Preferred Project Report

Malbec Properties / Saltwater Development South West Rocks

Part 3A Project Application MP 08_0167 | Malbec Properties | 5 August 2010

Figure 1 Amended Subdivision Plan

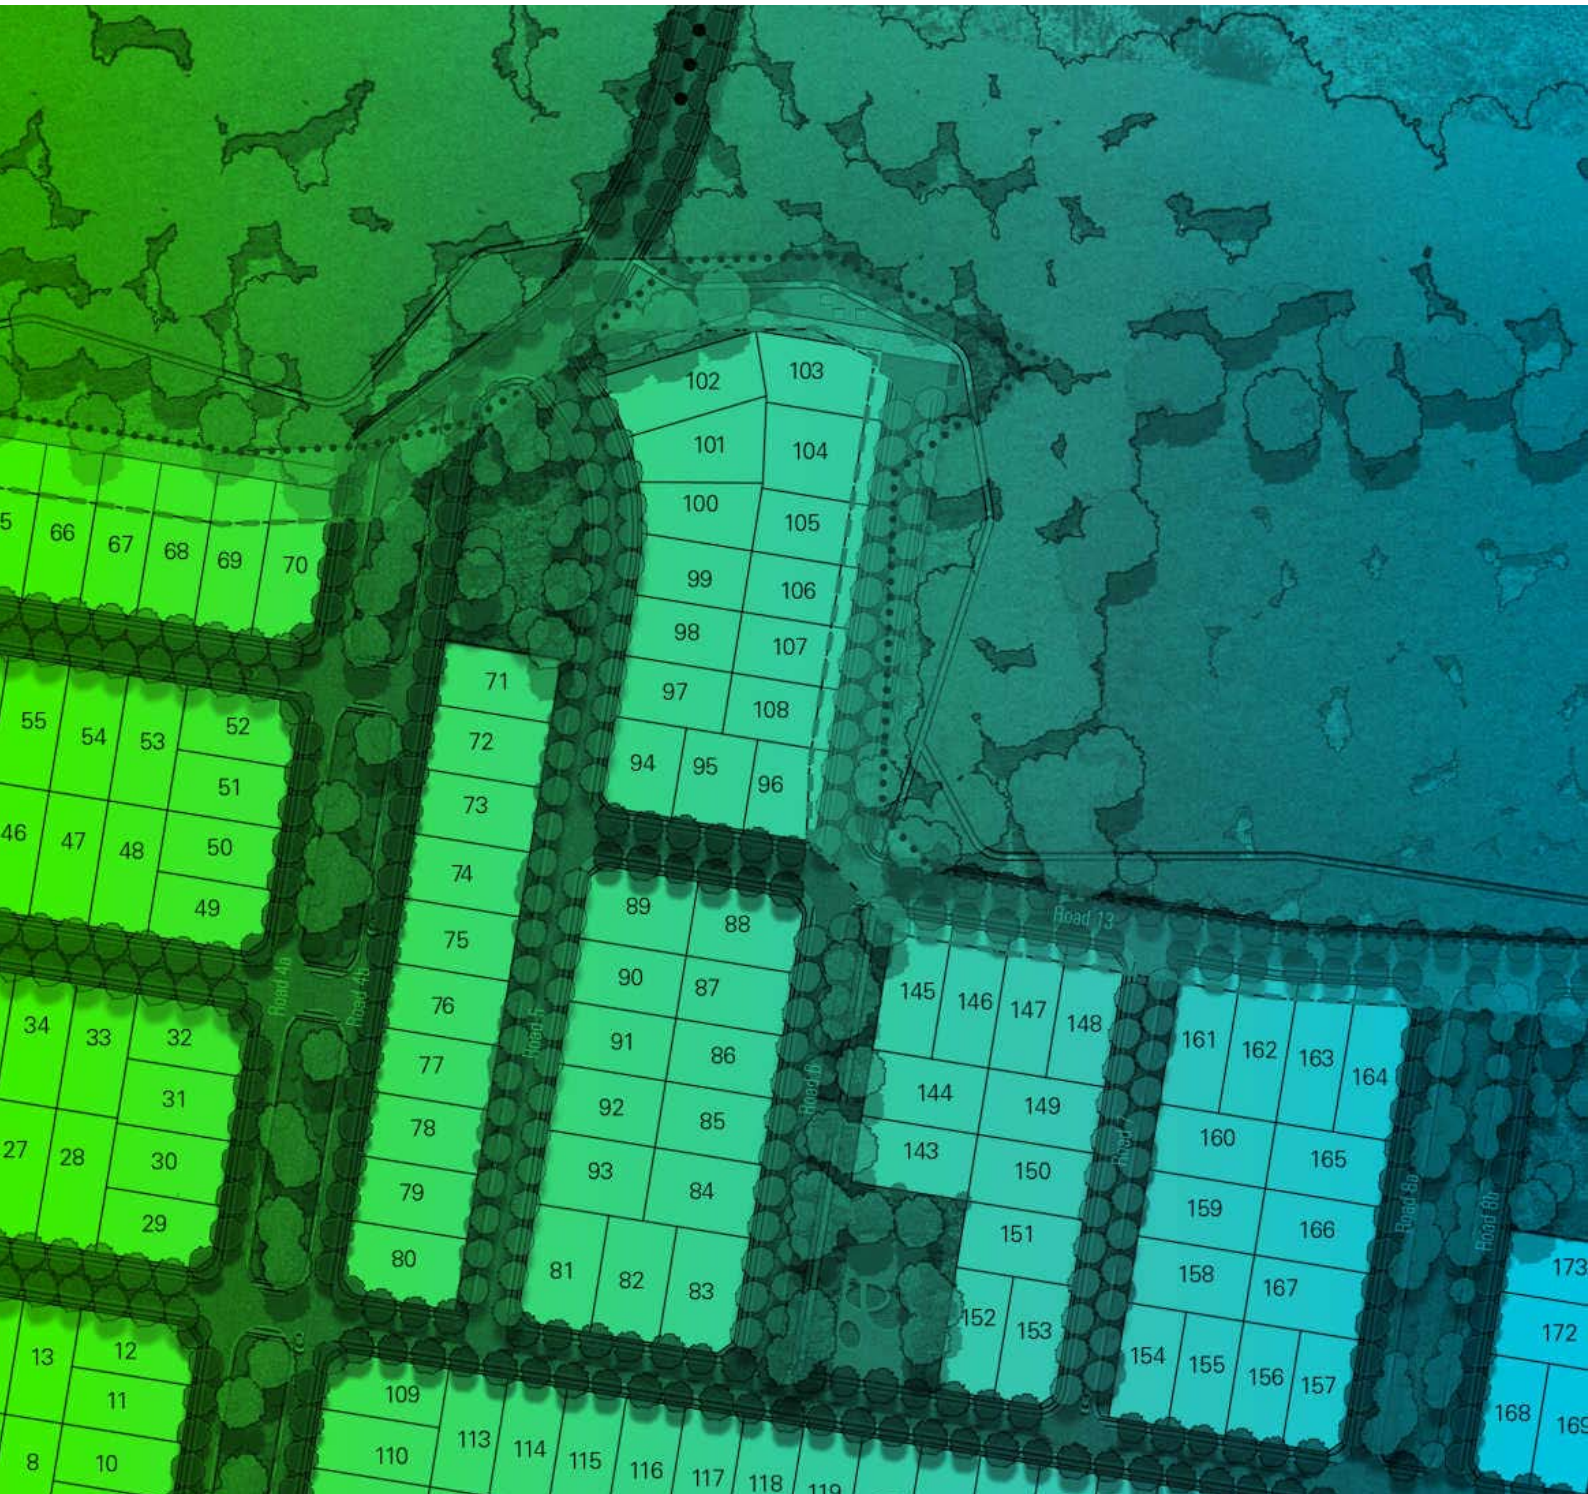
To address the concerns of the DoP, the revised scheme includes a reduction in total number of individual development lots by 50 lots from 318 lots to 268 lots.

The lots fronting the eastern property boundary have been reduced from ten to seven, to provide a better transition to the rural residential area adjacent to the site and to allow for better integration with the surrounding locality. As a result of a reduction in the total number of allotments fronting the eastern boundary, these lots have increased in size from 506 m² to 806 m².

- Reduction in total number of individual development lots by 50 lots from 318 lots to 268 lots, which is equivalent to an overall reduction of 8.4 %.
- Addition of one medium density super-lot within the western portion of the site to show consistency with Council's proposed Development Control Plan (DCP) for the area.

- Removal of Road 2 and all required asset protection zones (APZs) from within the 7(b) Environmental Protection (Habitat) Zone.
- Removal of cycleway from within the 7(a) Wetlands Protection Zone (as defined under *State Environmental Planning Policy No 14—Coastal Wetlands* (SEPP 14)).
